## **PLANNING COMMISSION MEETING AGENDA REGULAR MEETING**

**February 11, 2020**

## Special Use and Preliminary Site Plan Review For City of Troy, Michigan

<b>Applicant:</b>	Korean United Methodist Church
<b>Project Name:</b>	Church Parking Lot Expansion
<b>Plan Date:</b>	December 9, 2019
<b>Location:</b>	West side of Dequindre, south of Square Lake Road
<b>Zoning:</b>	R-1C Single Family Residential
<b>Action Requested:</b>	Special Use and Preliminary Site Plan Approval

DRAWING NUMBER:  
**C-2.1**

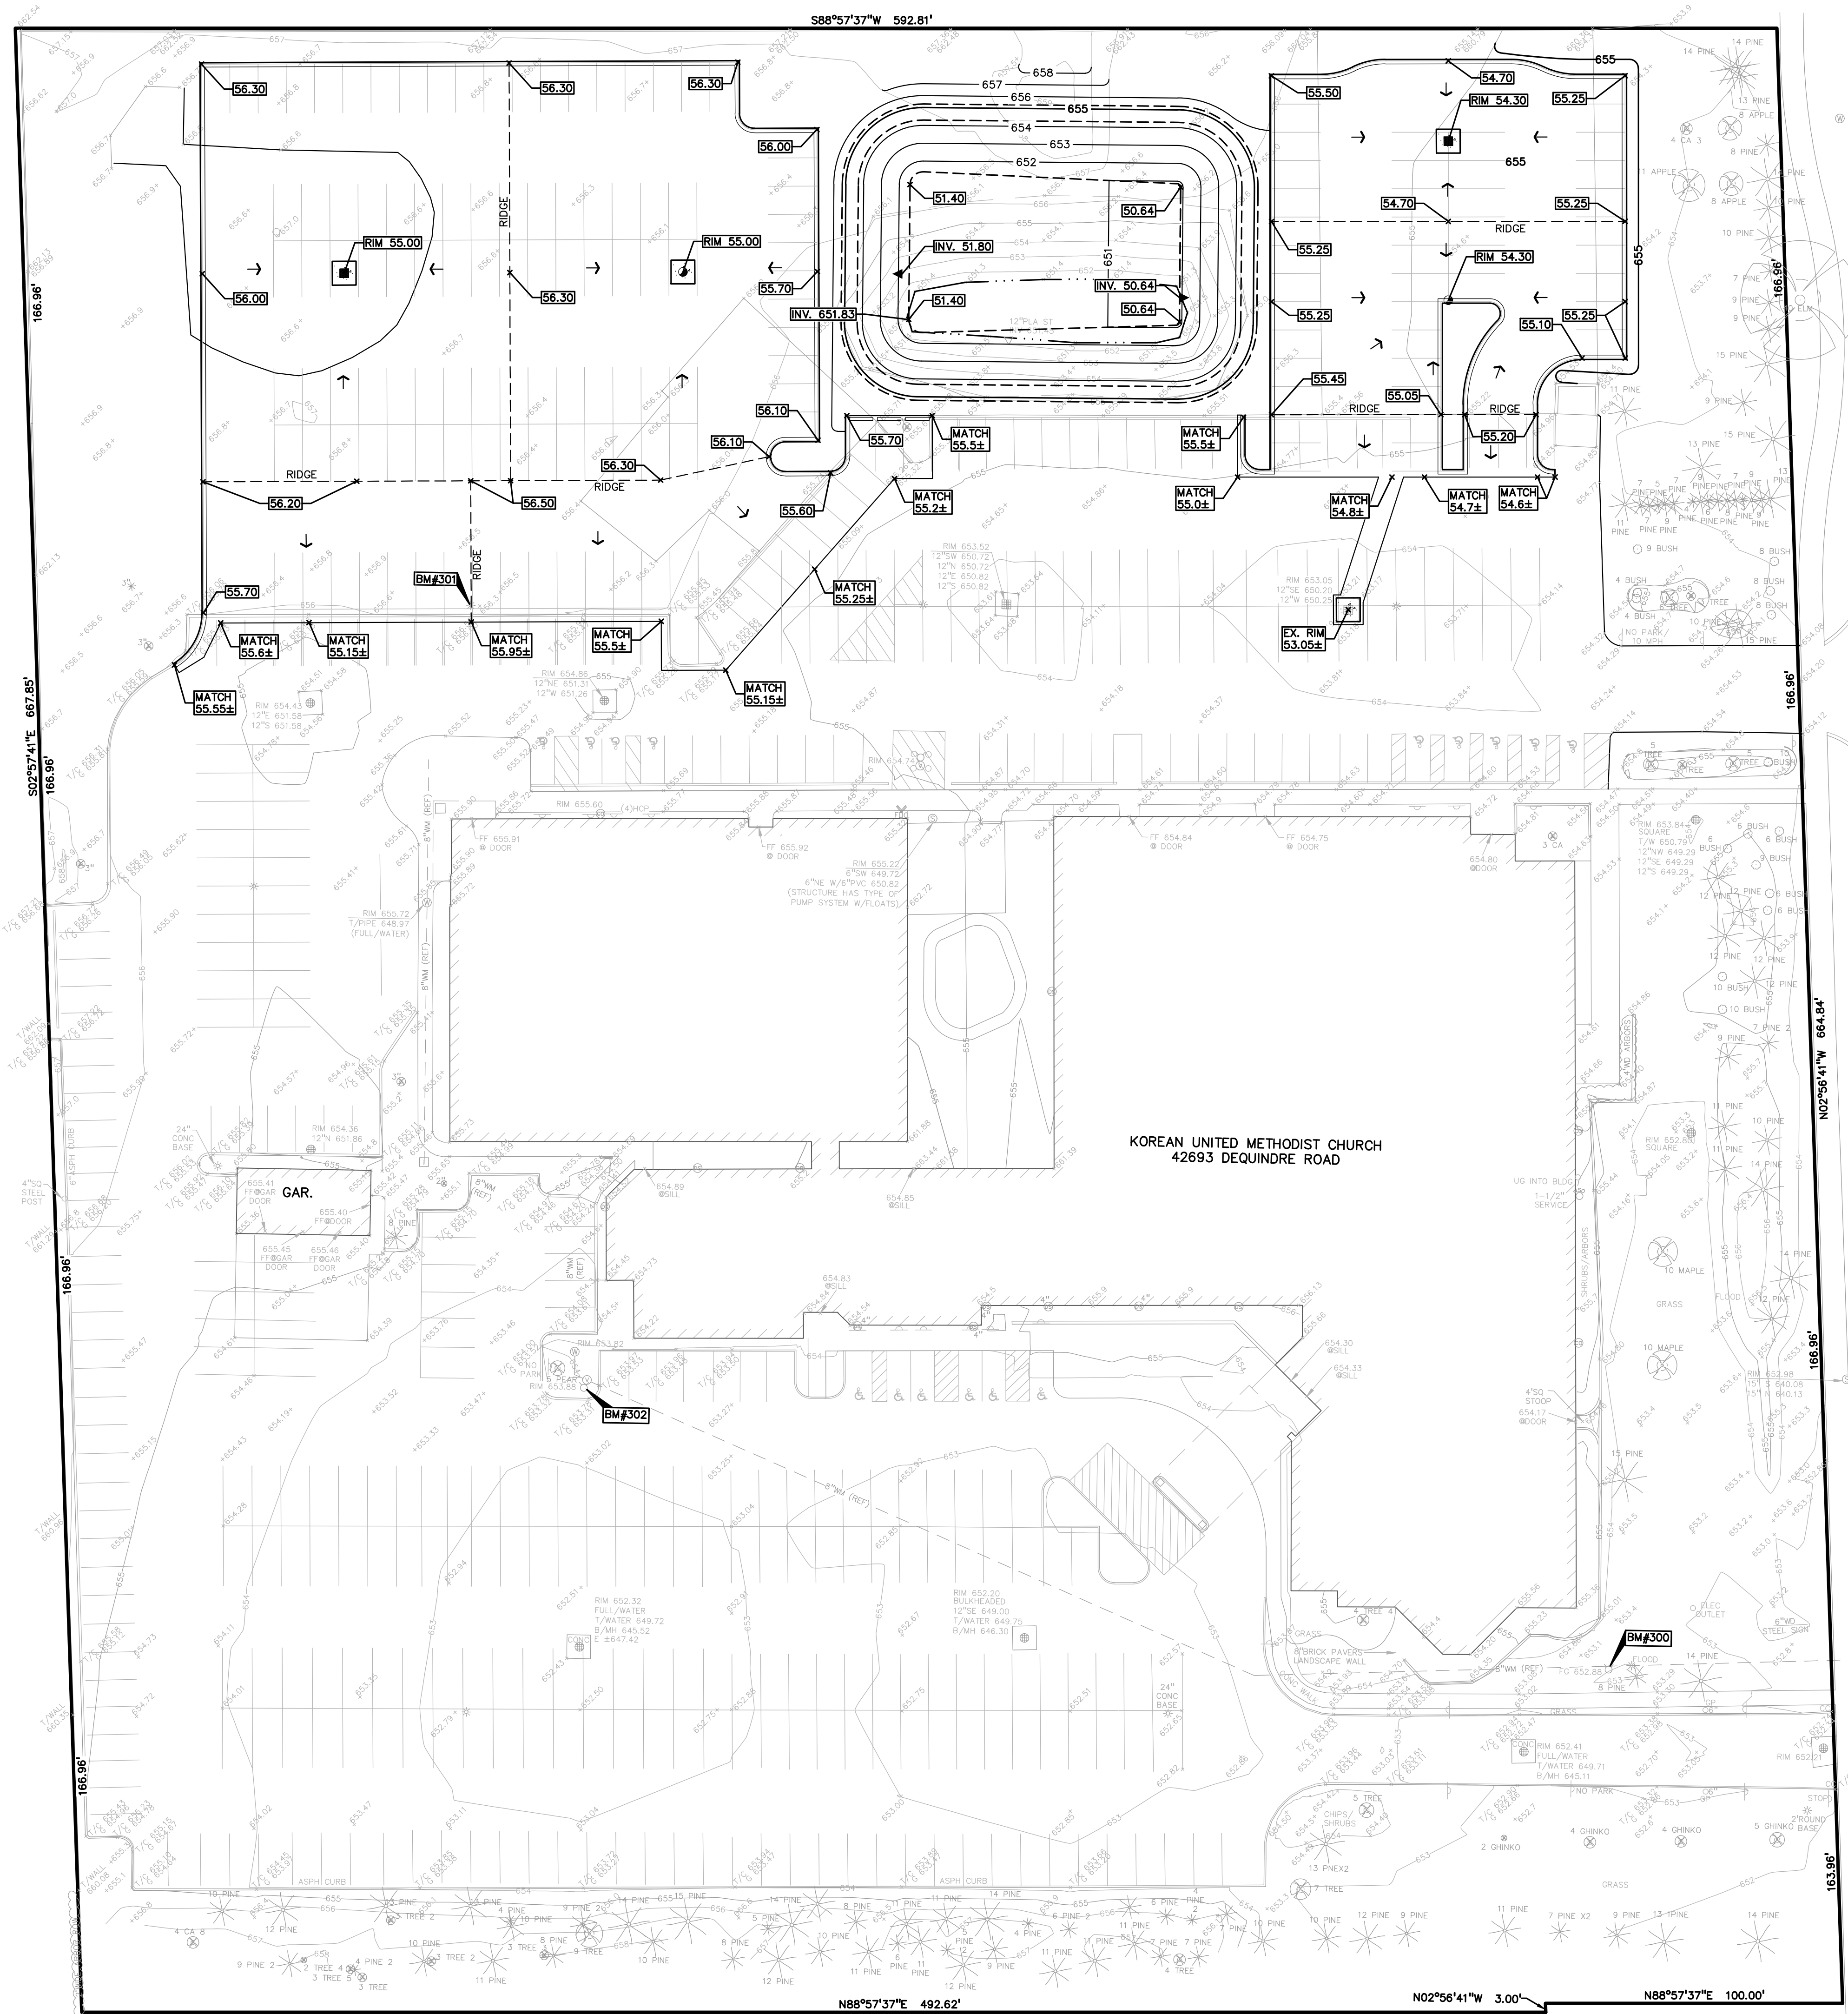
Based upon zoning ordinance requirements, the site already exceeds parking by 18%. With the additional parking, the applicant proposes to exceed the required parking by 59%. The applicant should prove to the satisfaction of the Planning Commission that the additional parking is necessary to accommodate the use on a typical day.

**Items to be Addressed:** 1). Prove to the satisfaction of the Planning Commission that the additional parking is necessary to accommodate the use on a typical day; and 2). As part of the special use review, the Planning Commission can put reasonable conditions upon the parking lot expansion such as the use of pervious paving.

We recommend that the Planning Commission hold a public hearing and discuss the need for additional parking to necessary to accommodate the use on a typical day. As part of the special use review, the Planning Commission can put reasonable conditions upon the parking lot expansion such as the use of pervious paving.

DRAWING NUMBER:  
**L-1.0**

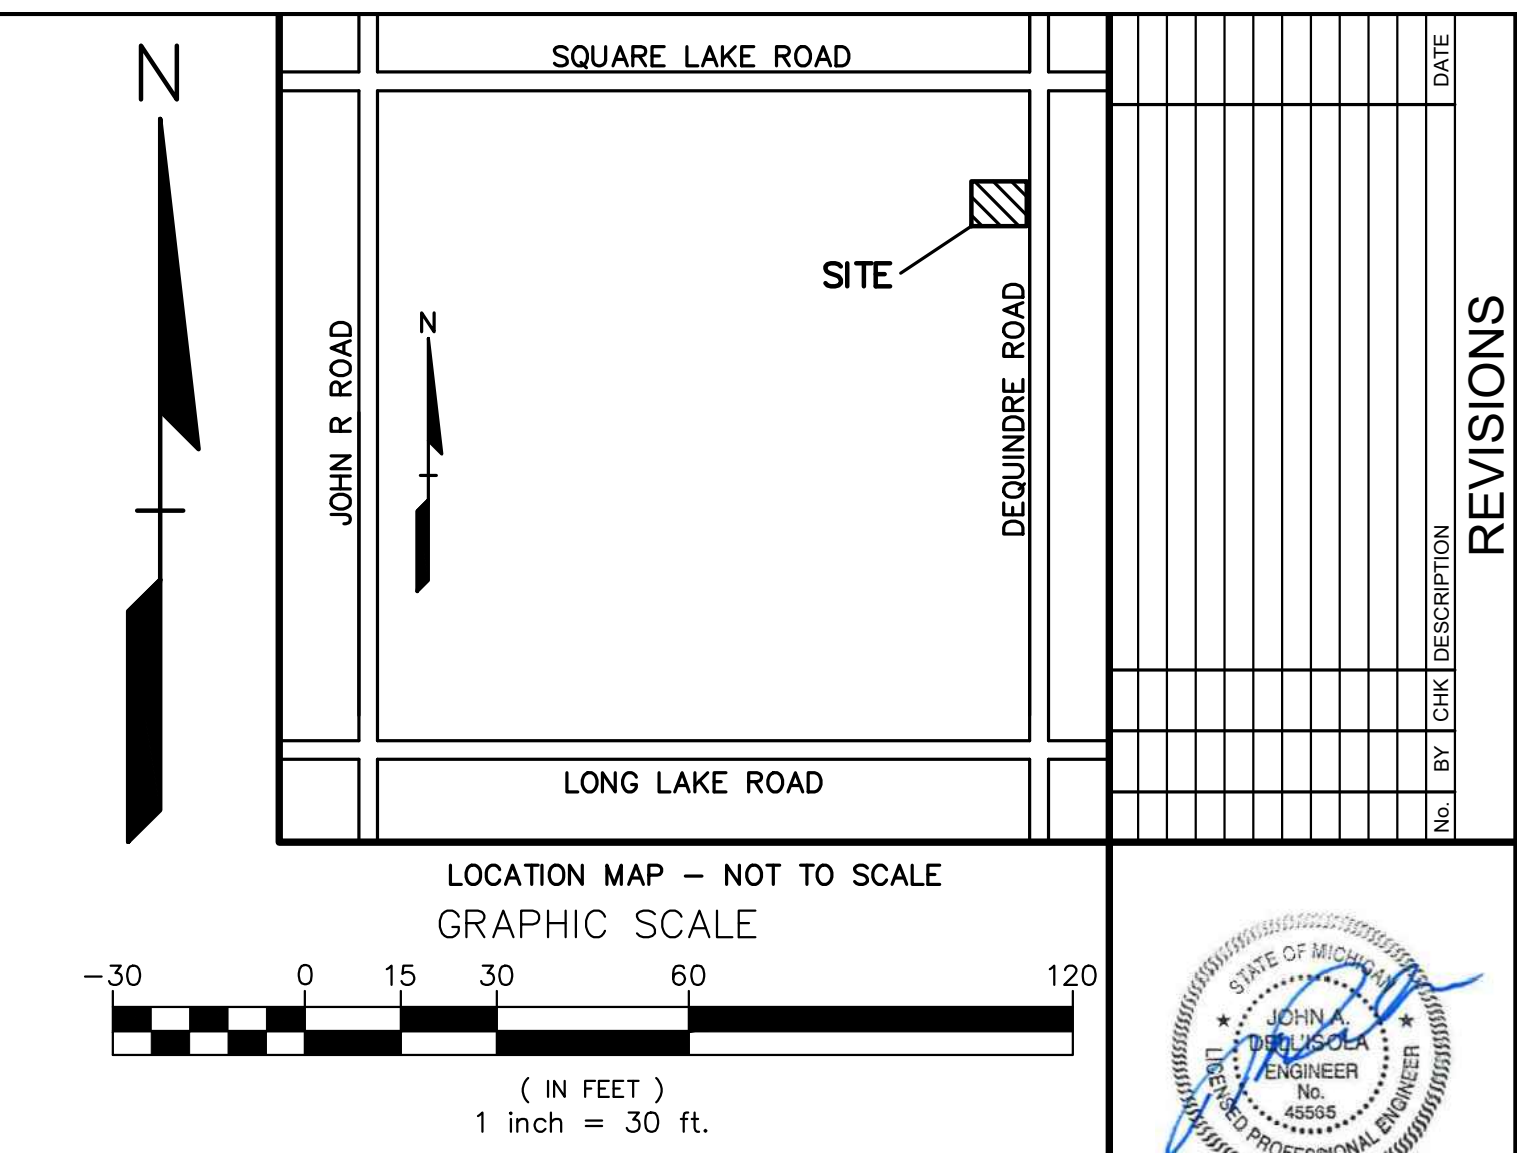
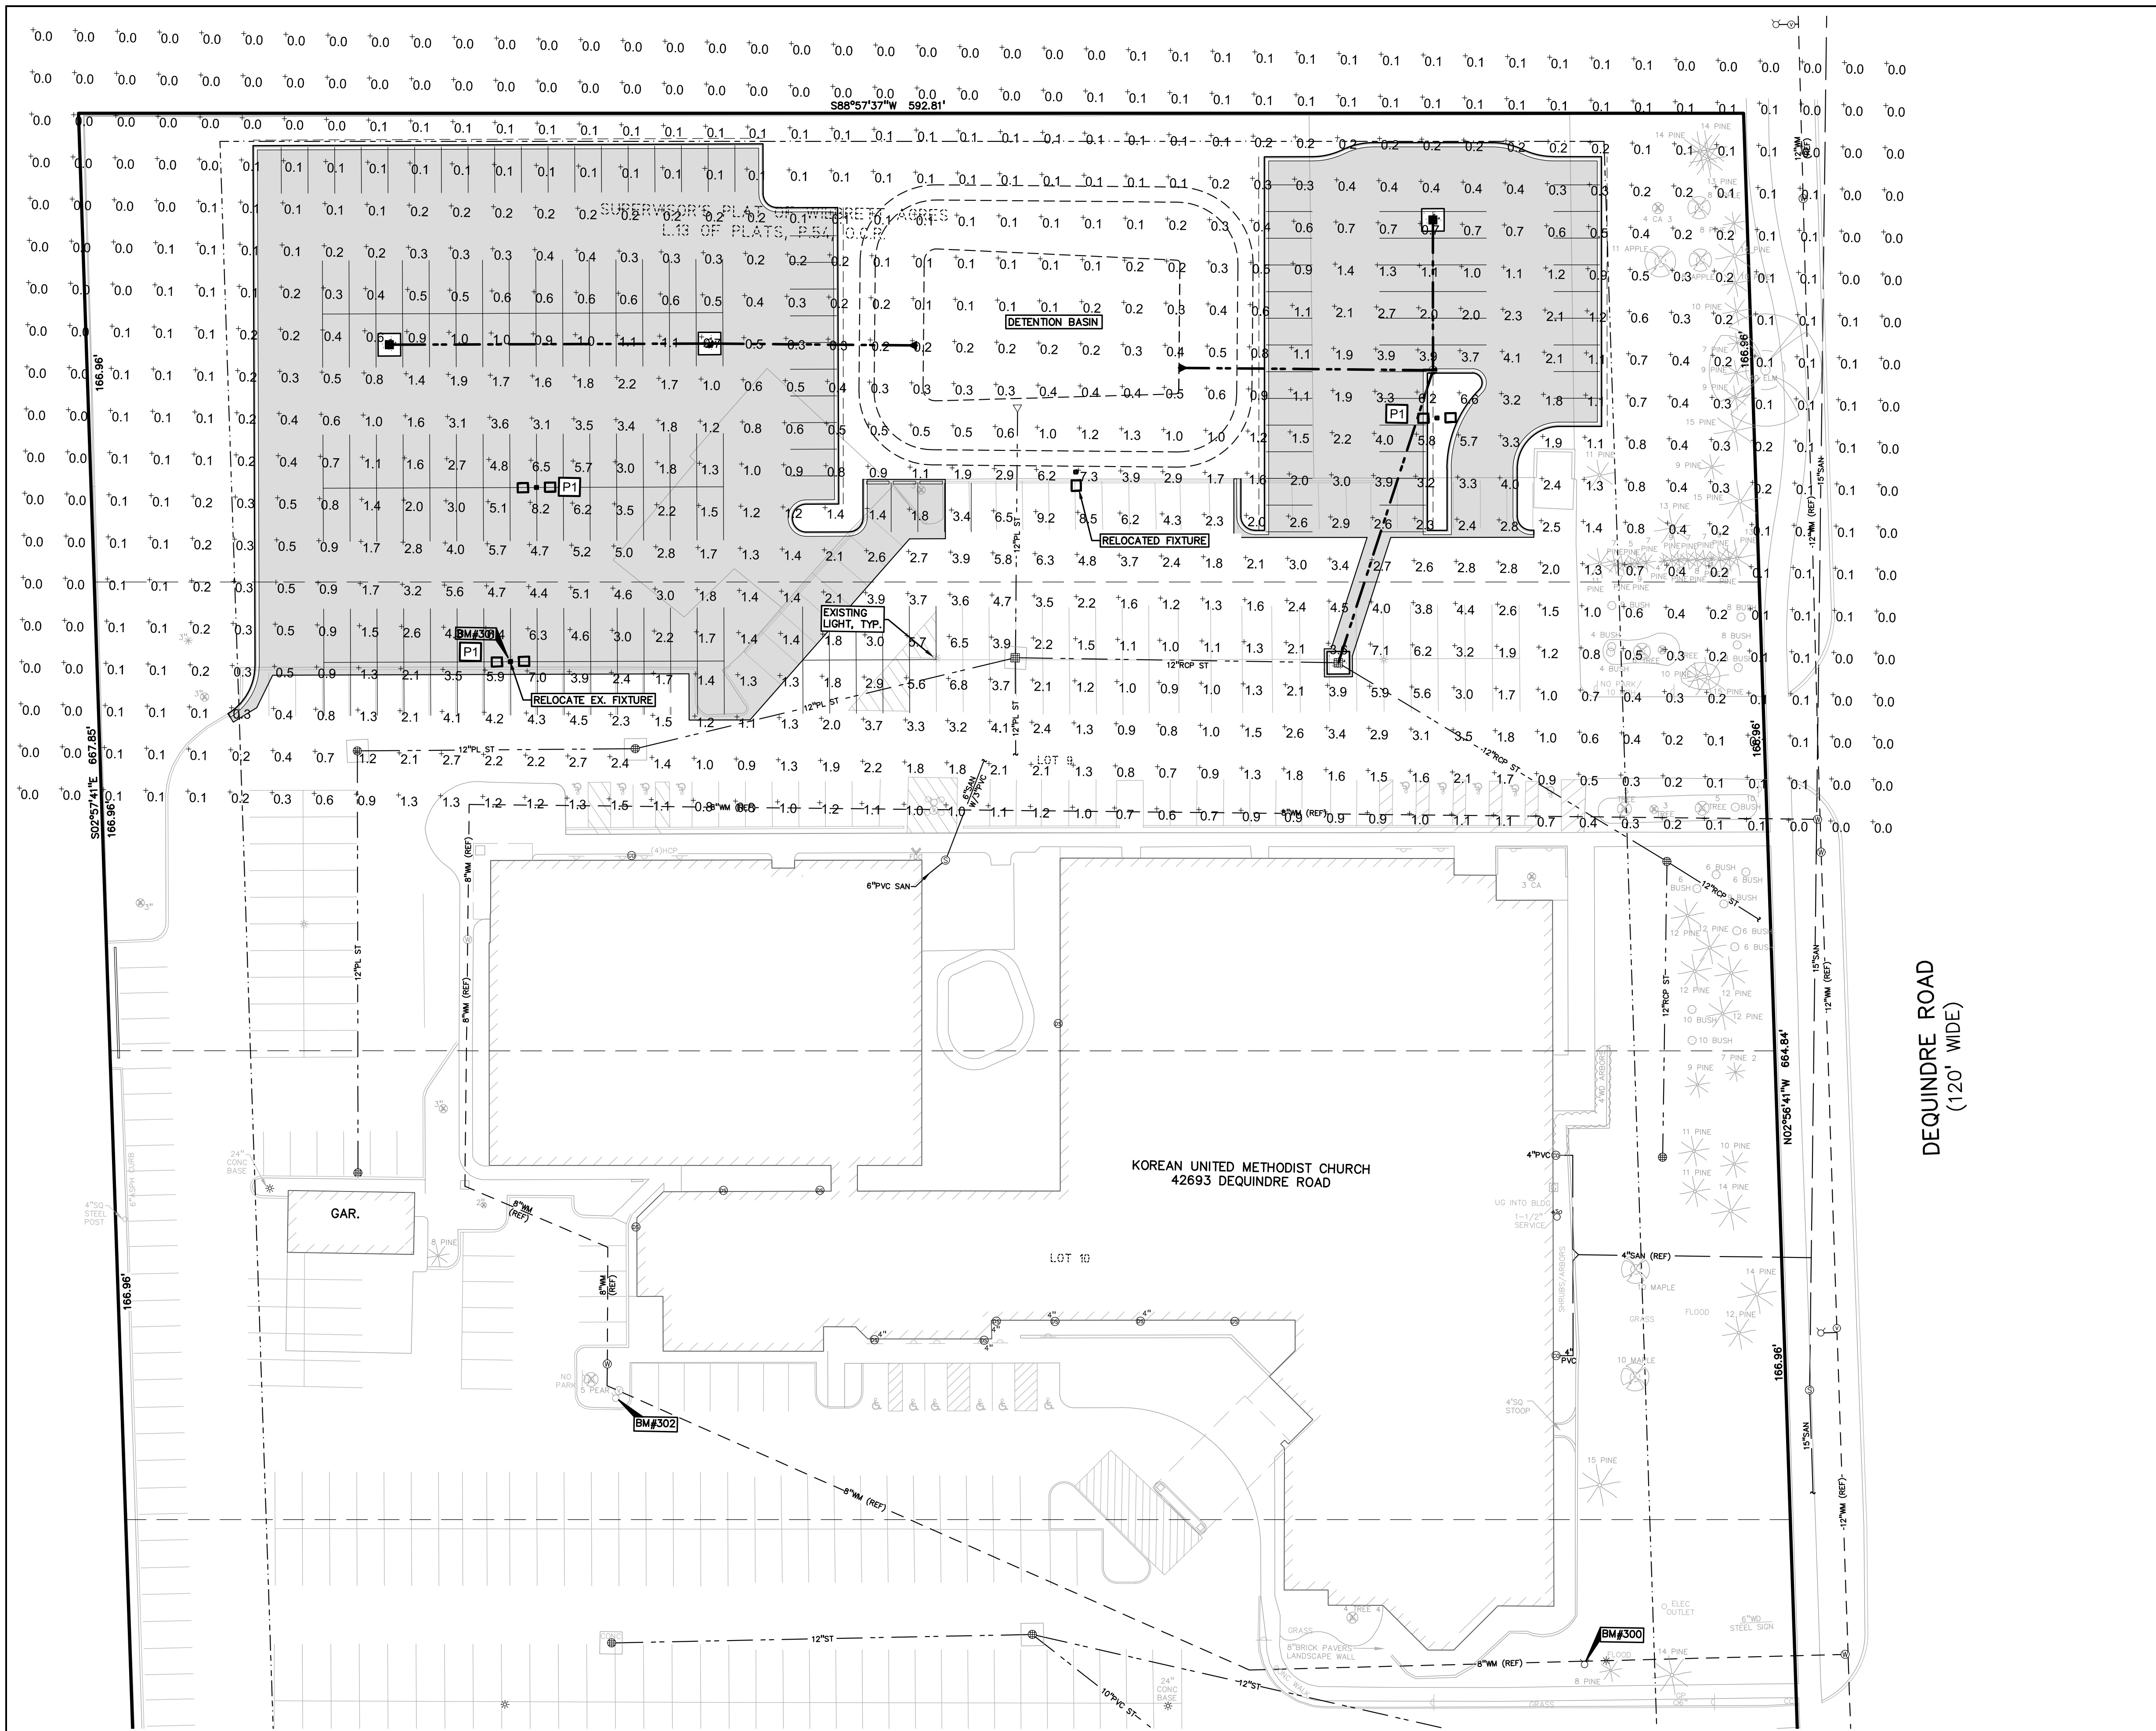
A landscaping plan has been provided on sheet L-1.0 and are supplemented by tree protection and planting details on sheet L-1.1. The following table discusses the development’s compliance with the landscape requirements set forth in Section 13.02.

The Planning Commission should consider requiring the applicant to add interior parking lot landscaping to break the long expanses of parking spaces.

**Items to be Addressed:** *The Planning Commission should consider requiring the applicant to add interior parking lot landscaping to break the long expanses of parking spaces.*

1. Require the applicant to add interior parking lot landscaping to break the long expanses of parking spaces.
